Product Change Notification / JAON-24XWVA797

CCB 4823 Final Notice: Qualification of MTAI as an additional final test site for selected SST26VF064B, and SST26VF064BA device families available in 16L SOIC (0.300in) package.

CCB 4823
Pre and Post Change Summary
PCN# JAON-24XWVA797

Pre and Post Change Summary – Carrier Tape

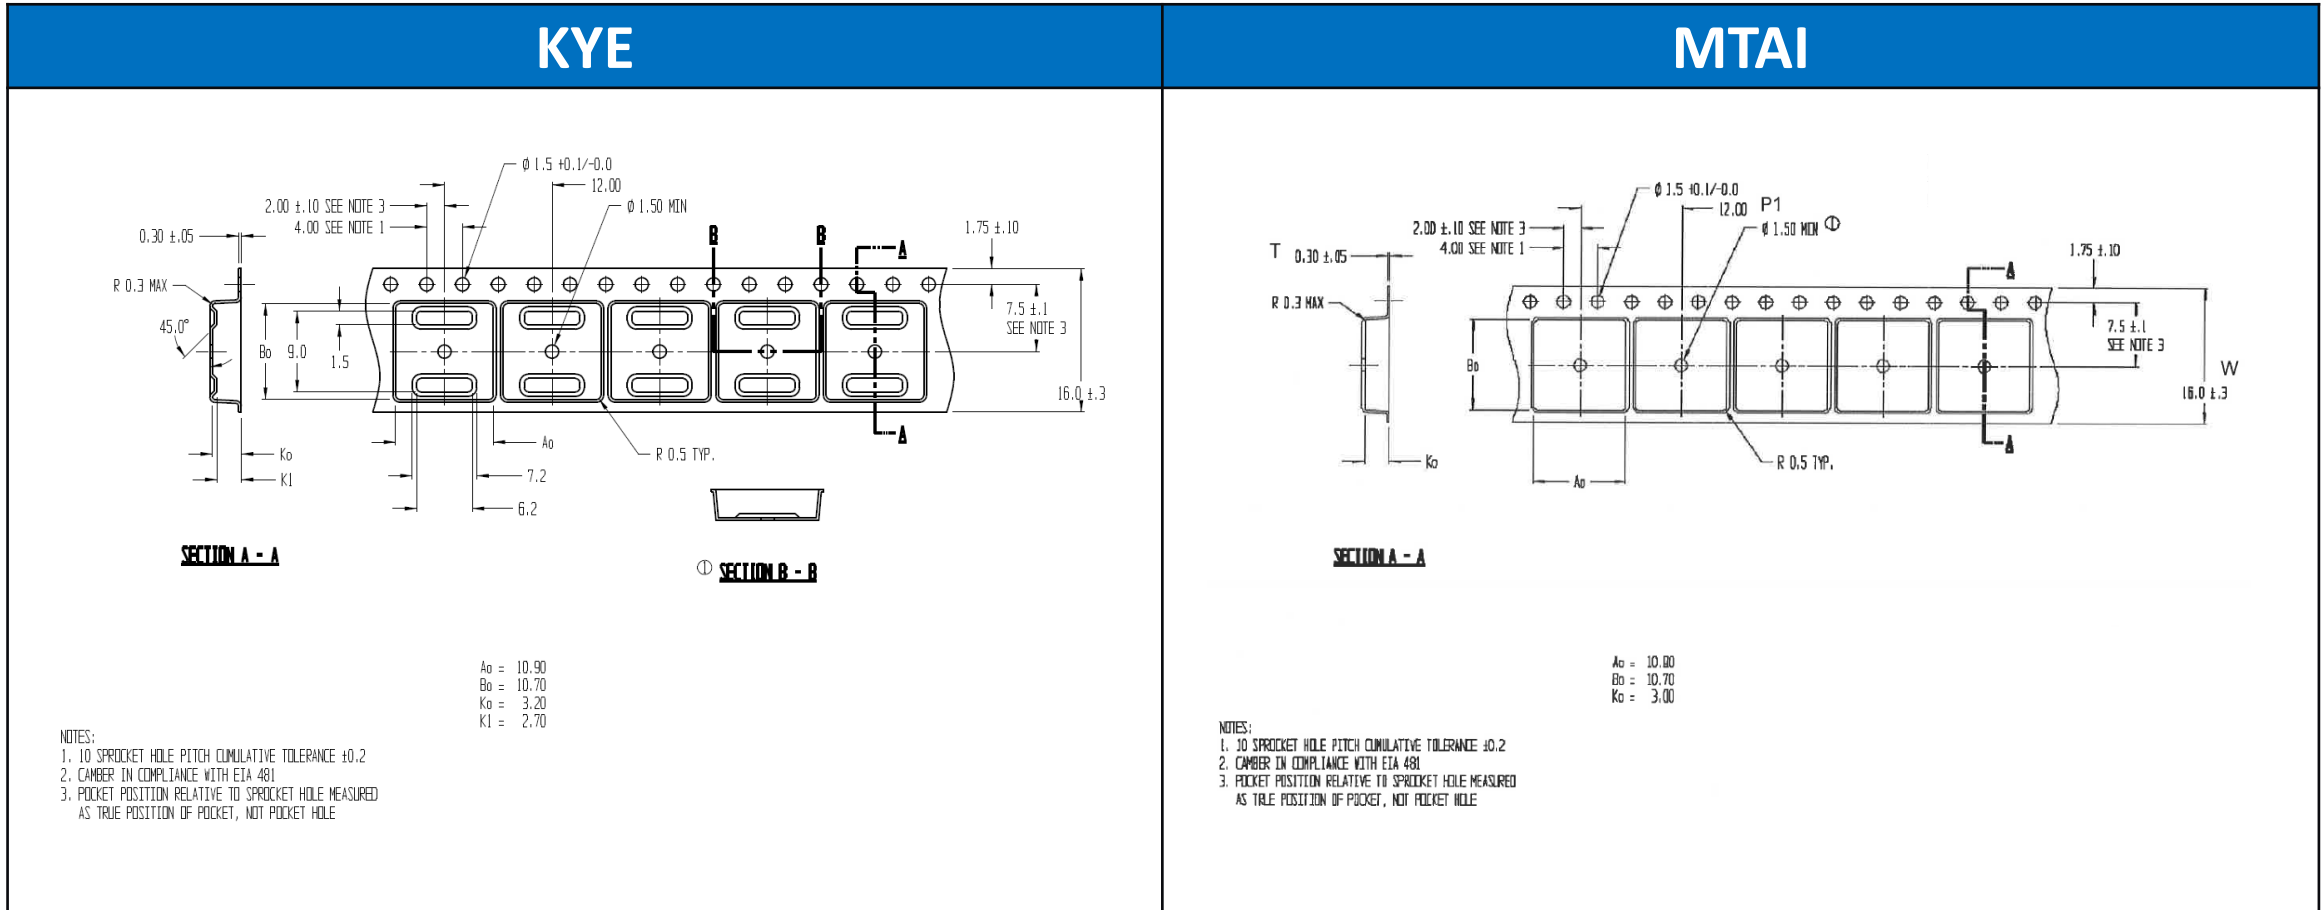
Plant	W (mm.)	P (mm.)	A0 (mm.)	B0 (mm.)	K0 (mm.)	K1 (mm.)	Thickness	BQM	Pin1
MTAI	16.00 ± 0.30	12.00 ± 0.10	10.90 ± 0.10	10.70 ± 0.10	3.00 ± 0.10	-	0.30 ± 0.05	1000	Quadrant 1
KYE	16.00 ± 0.30	12.00 ± 0.10	10.90 ± 0.10	10.70 ± 0.10	3.20 ± 0.10	2.70 ± 0.10	0.30 ± 0.05	1000	Quadrant 1

Pre and Post Change Summary – Cover Tape

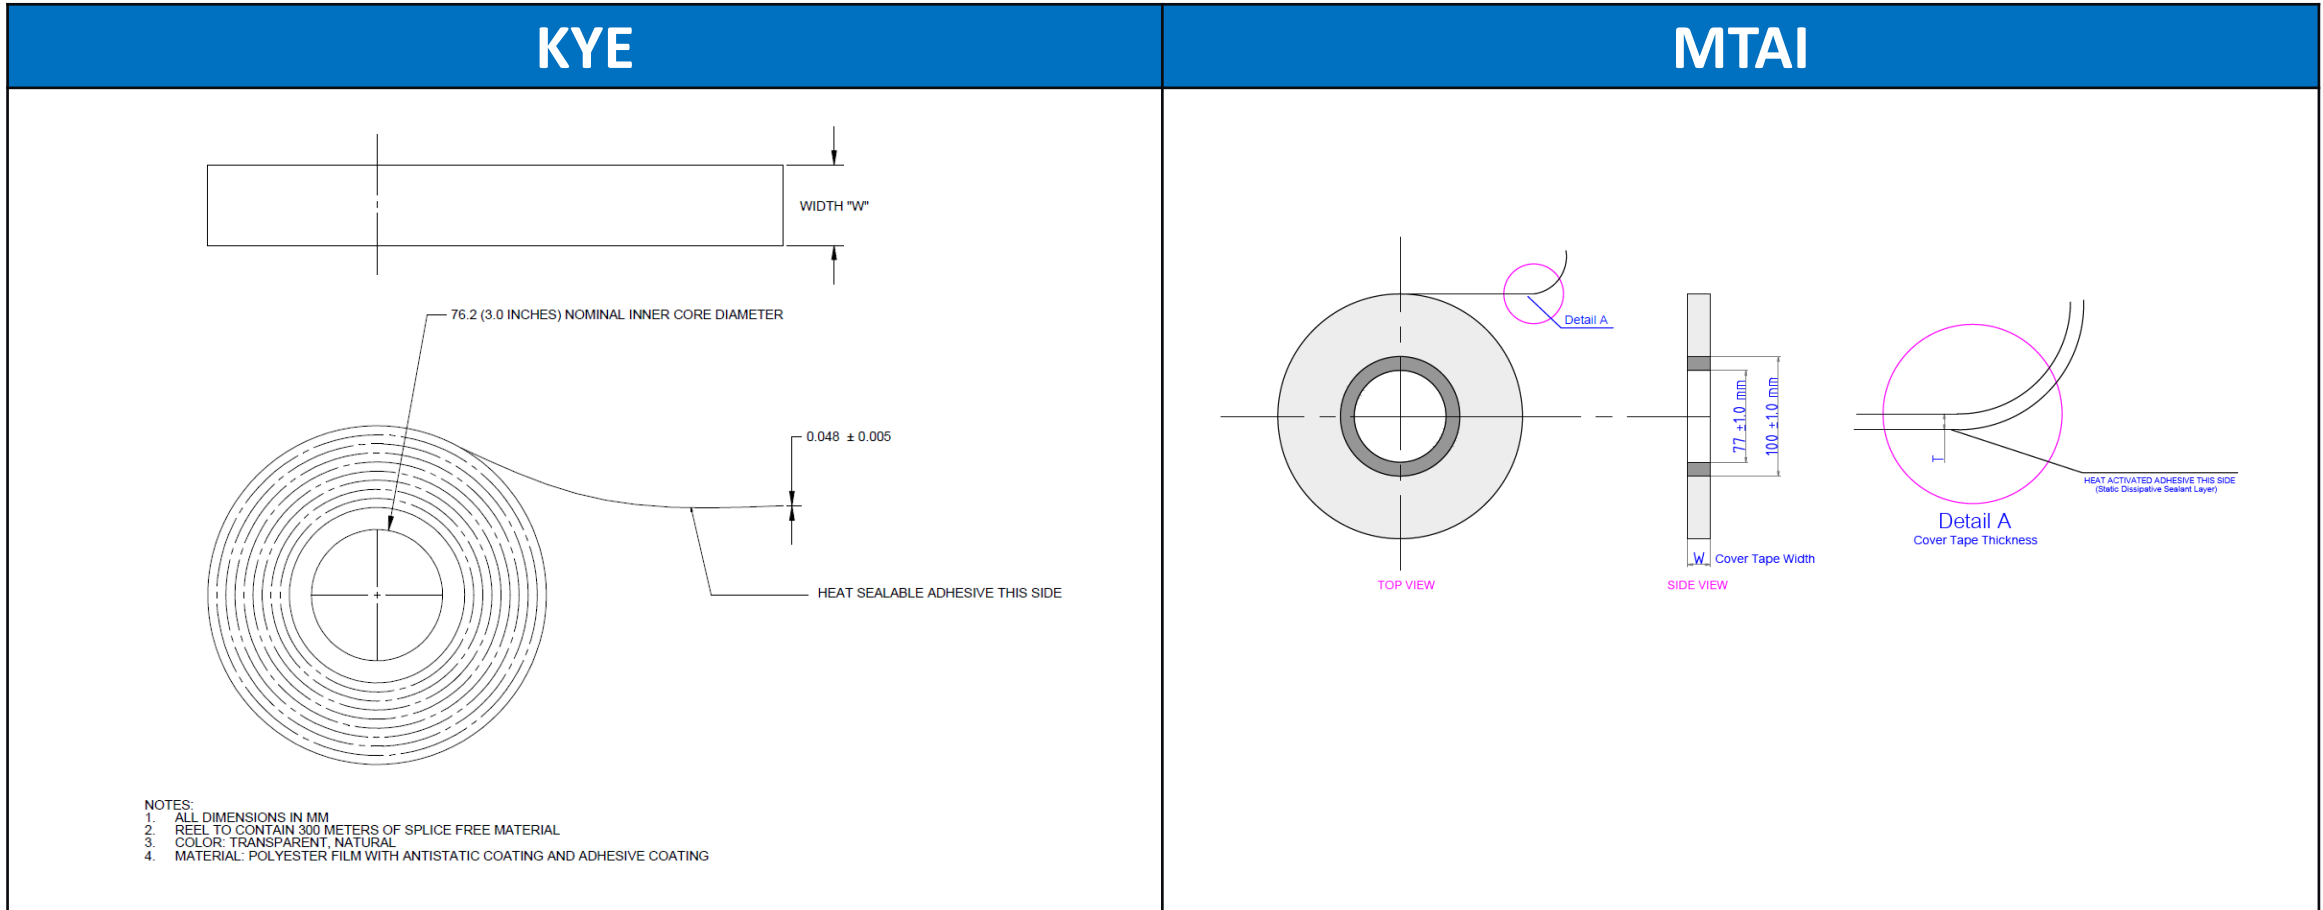
Plant	Width W (mm.)	Thickness T (mm.)	Color	Sealing Methodology
MTAI	13.3 ± 0.1	0.050 ± 0.010	Clear	Heat Seal
KYE	13.3 ± 0.1	0.048 ± 0.005	Clear	Heat Seal

Pre and Post Change Summary – Plastic Reel

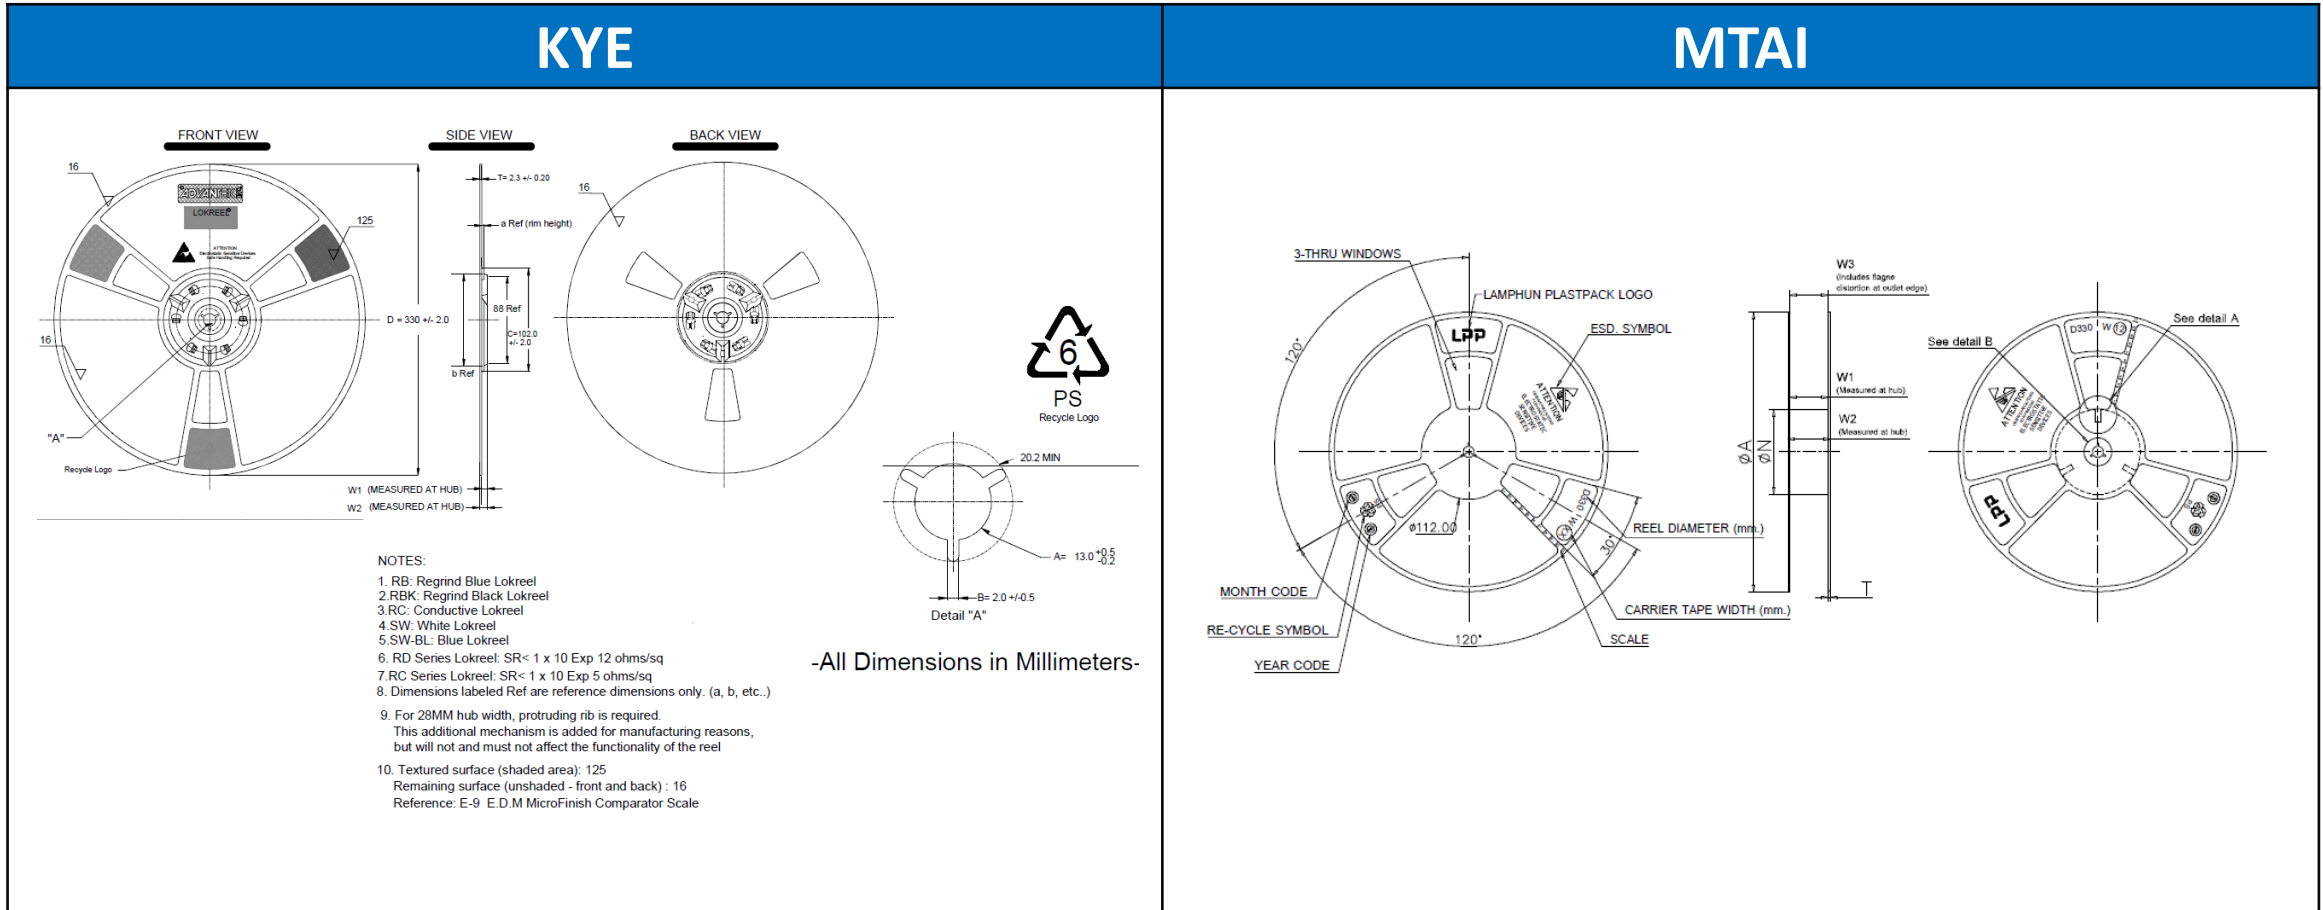
Plant	Reel Diameter (mm.)	Reel Hub Size (mm)	Reel Width Max (mm.)	Color
MTAI	330 ±2.0	100 ±2.0	22.40	Dark Blue
KYE	330 ±2.0	102±2.0	8.4+0.3/-0.2 + 8.4+0.3/-0.2	Regrind Blue

Pre and Post Change Summary – Tube

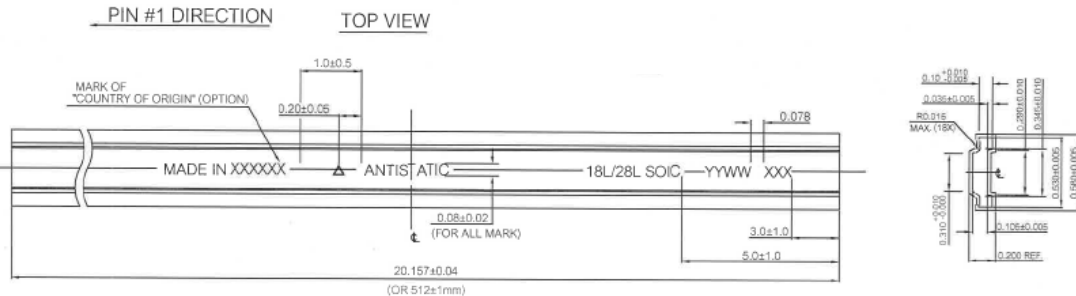
KYE	MTAI
<p style="text-align: center;">Not Applicable Tested at KYE but Scan & Packed at MTAI</p>

Plant	Tube Length (in)	Dimension A (in)	Dimension B (in)	Tube Color	BQM Per media
MTAI	20.157 ± 0.04	0.580 ± 0.005	0.200 ± 0.01	Clear	47
KYE	N/A

Pre and Post Change Summary – Tube Packing Method

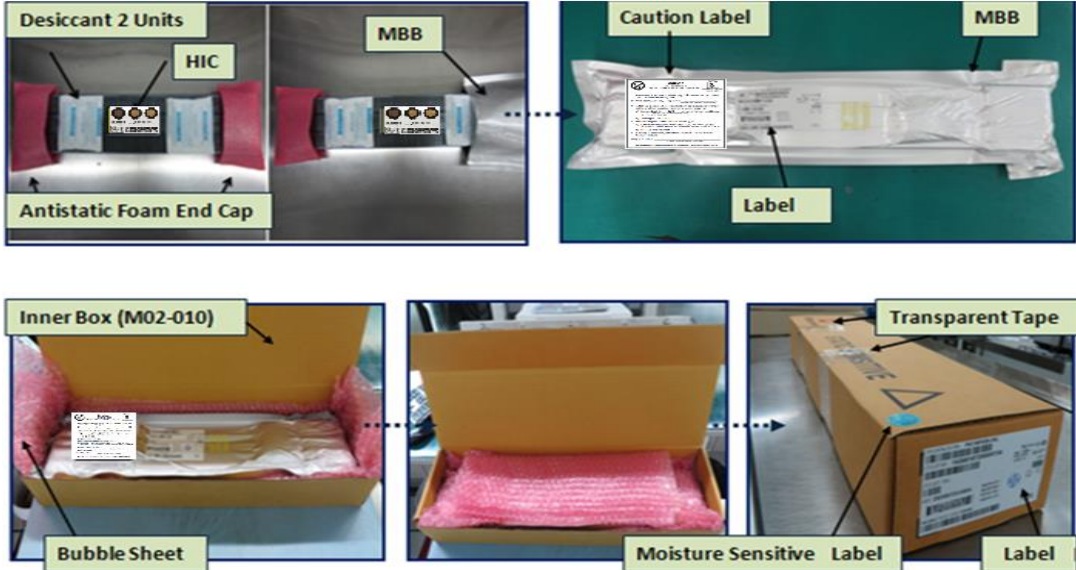
KYE	MTAI
<p data-bbox="275 616 1065 714">Not Applicable Tested at KYE but Scan & Packed at MTAI</p>	 <p>The MTAI process involves the following steps and components:</p> <ul style="list-style-type: none">Two units are placed in a tube with desiccant and HIC.The tube is sealed with antistatic foam end caps and MBB.The tube is placed in an inner box (M02-010) with a bubble sheet.The inner box is placed in a larger box with a moisture sensitive label.The larger box is sealed with transparent tape and a final label.
